Re: State Center Fire Department  
Renovation & Addition – Redesign  
109 E Main Street  
State Center, Iowa 50247

## ADDENDUM #02

January 09, 2026

1 LIGHTING PLAN  
1/8" = 1'-0"

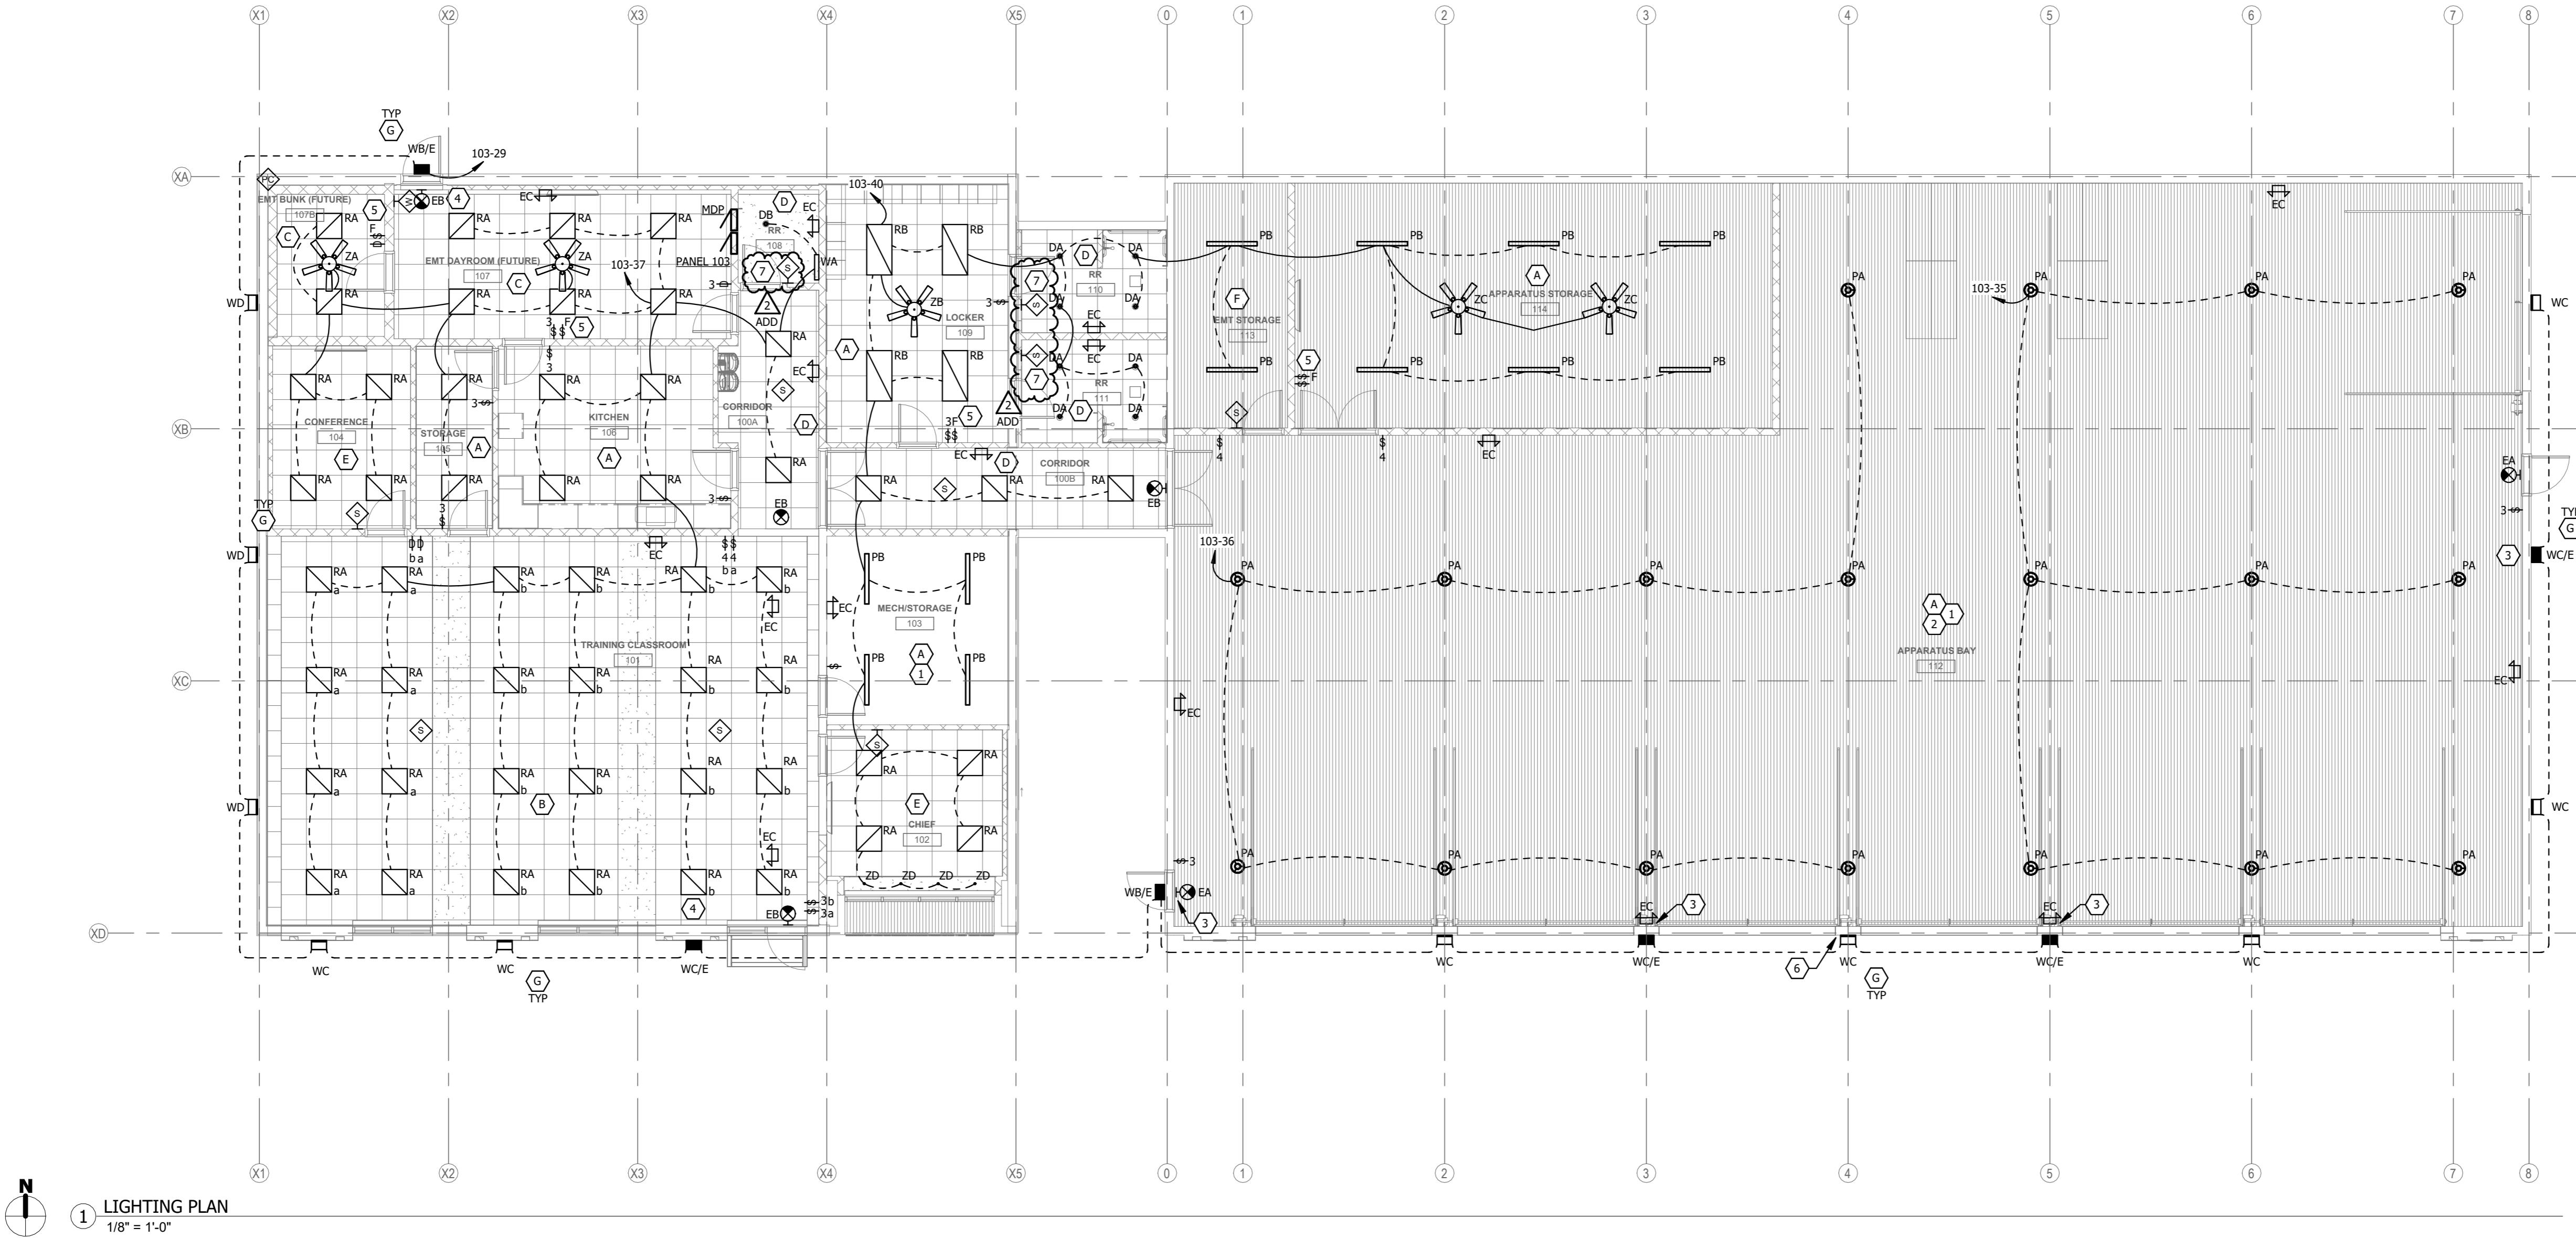
- 1. Lighting Plan
  - A. **ADD** referenced note 7 tag to lighting control switches in RR 108, RR 110, and RR 111.
- 2. Referenced Notes
  - A. **ADD** referenced note 7 that reads "CONTROL DEVICE SHALL HAVE AN ADDITIONAL AUXILIARY RELAY FOR CONTROL OF RESTROOM EXHAUST FAN. EXHAUST FAN SHALL OPERATE WITH THE LIGHTING."
